## Permit to Alter Case Report

*Hearing Date:* August 15, 2012  
*Filing Date:* July 23, 2012  
*Case No.:* 2012.0502H  
*Project Address:* 1355 MARKET STREET (aka 1301-1363 MARKET STREET)  
*Conservation District:* N/A  
*Category:* Category I (Significant) – Western Furniture Exchange  
*Zoning:* C-3-G (Downtown General Commercial)  
120-X-200-S Height and Bulk District  
*Block/Lot:* 3508/001  
*Project Sponsor:* Elisa Skaggs  
Page & Turnbull  
1000 Sansome Street, Suite 200  
San Francisco, CA 94111  
*Staff Contact:* M. Pilar LaValley - (415) 575-9084  
[pilar.lavalley@sfgov.org](mailto:pilar.lavalley@sfgov.org)

## PROPOSED NINTH STREET ELEVATION

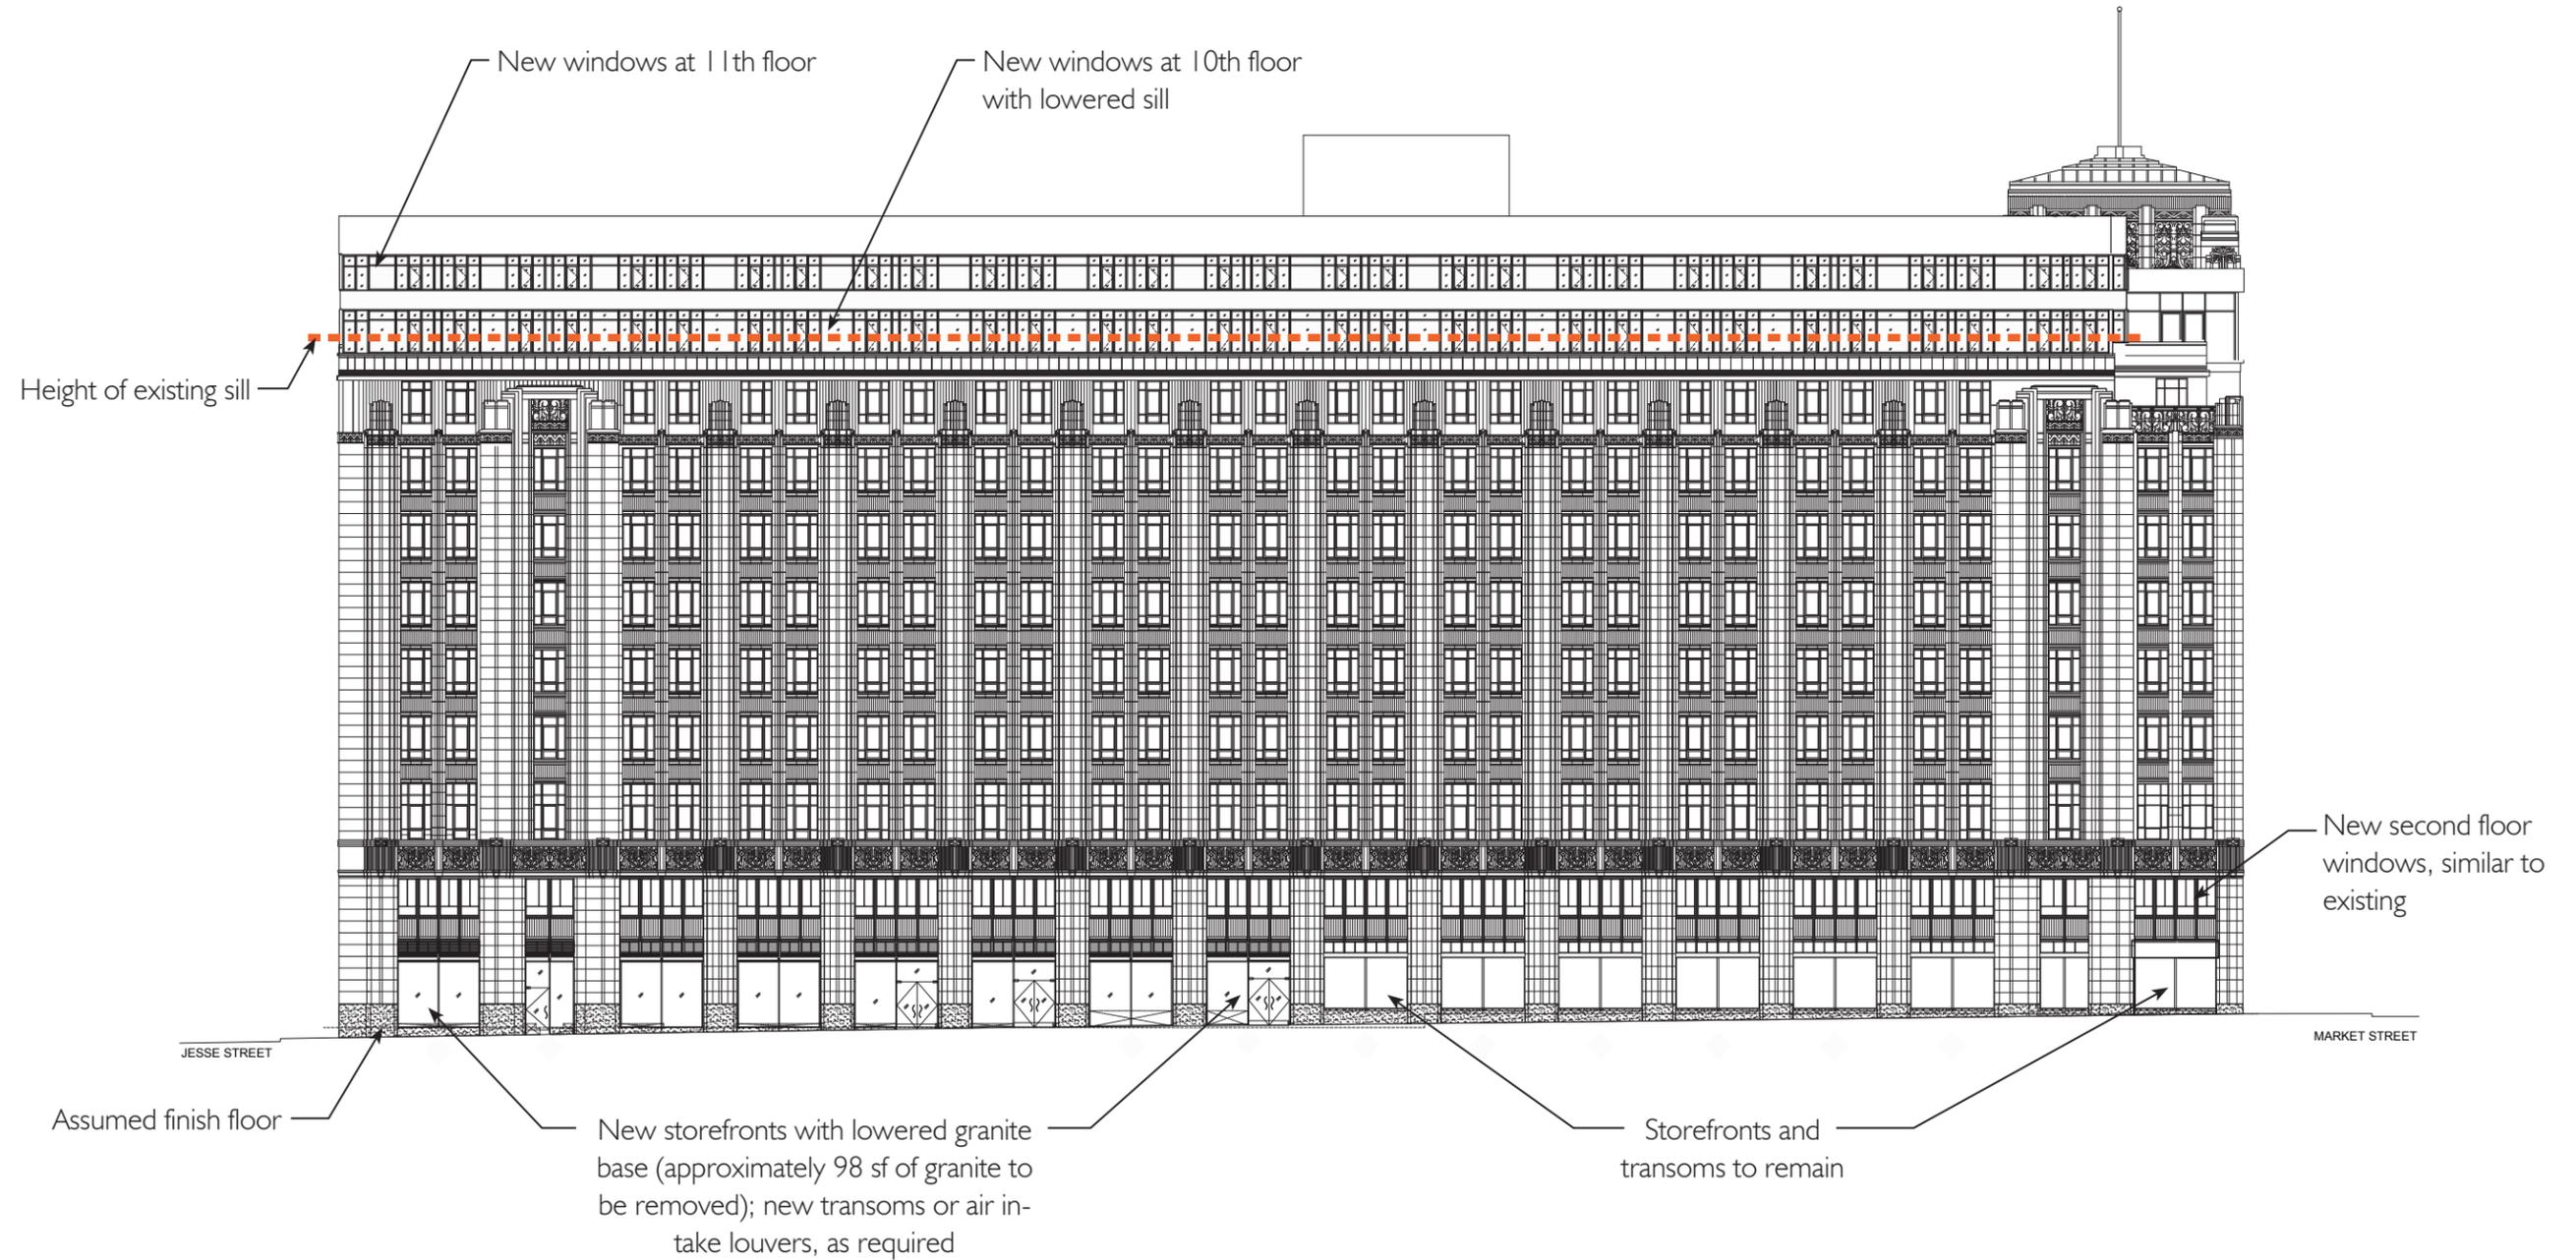
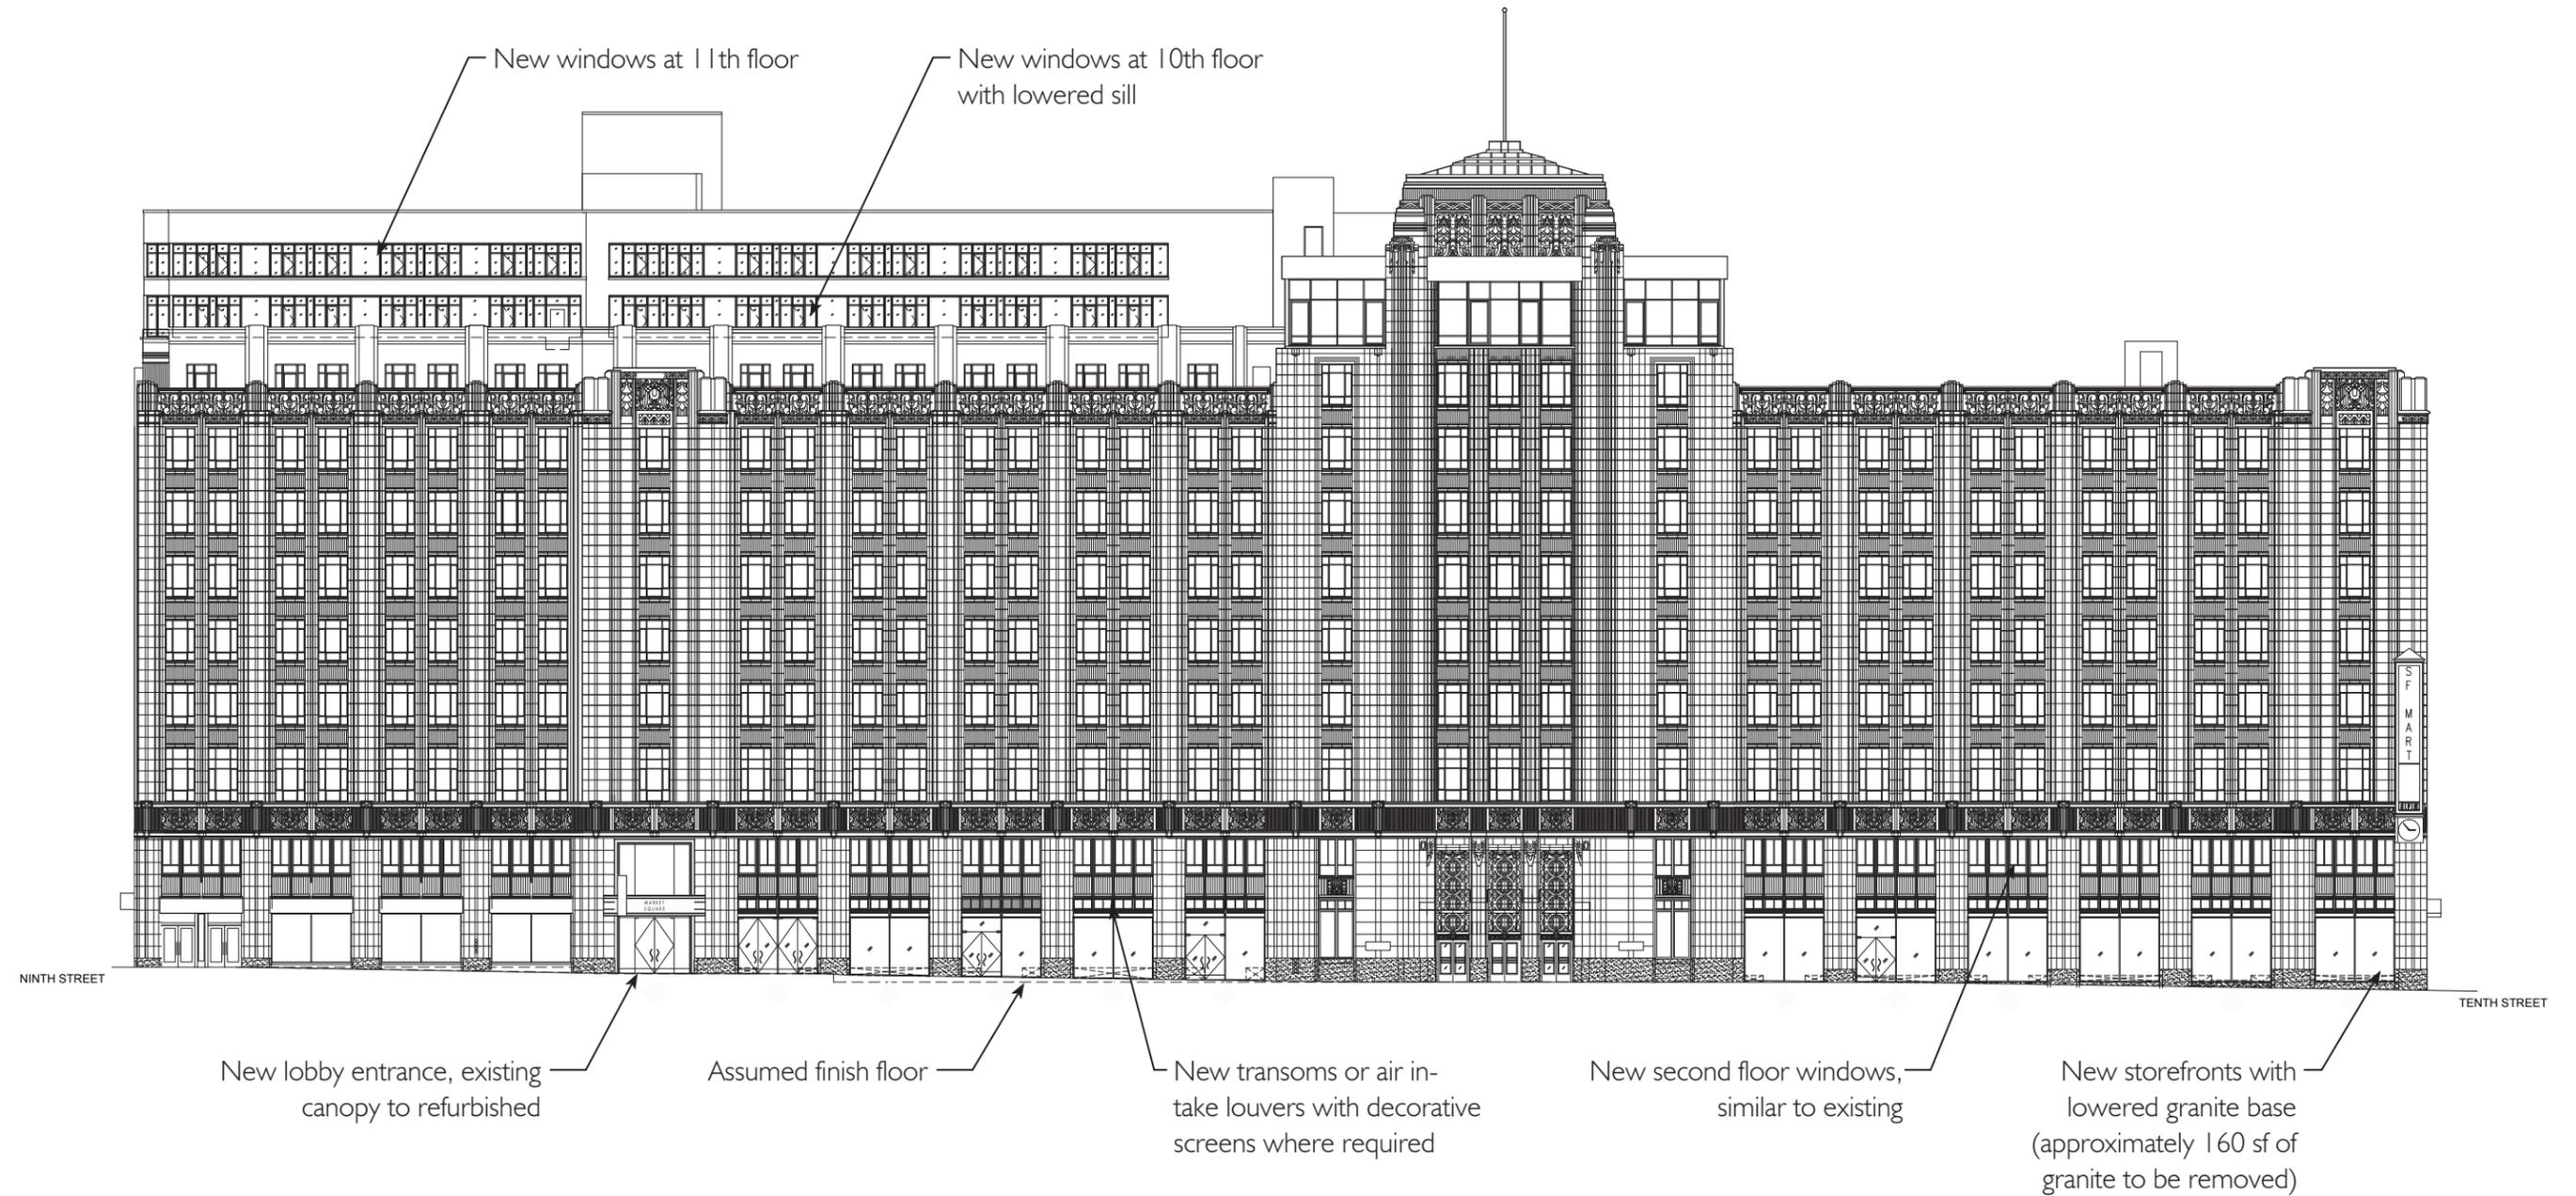
The removal, and significant reduction in height, of the existing granite base, as proposed in the project variant, does not appear to be in conformance with the *Secretary's Standards* as it would inappropriately remove historic fabric that contributes to the architectural character of the building. While the subject building has always been in commercial use, its design and architectural character is that of a wholesale facility with multiple showrooms accessed from a primary, central entrance. The building did not historically have multiple storefront entrances for different commercial tenants. In this sense, the building's storefronts and base are similar to a Department Store and this aspect of the building's architectural character is part of what makes it distinctive and historically significant. Further, the extension of new storefronts to street grade where base is removed, as proposed, is not in conformance with the Department's Storefront Standards (draft) or the *Secretary's Standards*. As noted in the Department's Storefront Standards (draft), a raised bulkhead, usually clad in masonry or tile, is a typical storefront feature of buildings from this period. Historic photographs of the subject property demonstrate that the granite clad base, which relates to the granite clad water table at base of the building piers, is a historic feature, even though some sections may have been altered or removed. Both the Department's Standards and the *Secretary's Standards* recommend preserving rather than removing or replacing extant historic fabric. Extension of the storefront glazing to street grade is also not compliant with the Department's Storefront Standards (draft) as it is a very contemporary storefront configuration that is not compatible with the character of the subject building.

Removal and significant reduction in height of the granite base, and extension of the storefronts to street grade, would remove distinctive historic fabric and introduce a storefront system that is not compatible with the historic and architectural character of the building. Removal of the granite base would inappropriately alter overall form, scale, proportion, and character of the storefronts and base of the building, leaving “missing teeth” in place of historic fabric that could be easily retained and integrated into the new storefronts and ground floor uses. As such the proposed Option 1 does not appear to be in conformance with the *Secretary’s Standards* and would be a significant impact on the resource as it would damage/destroy historic fabric, distinctive materials, and character-defining features.<sup>2</sup>
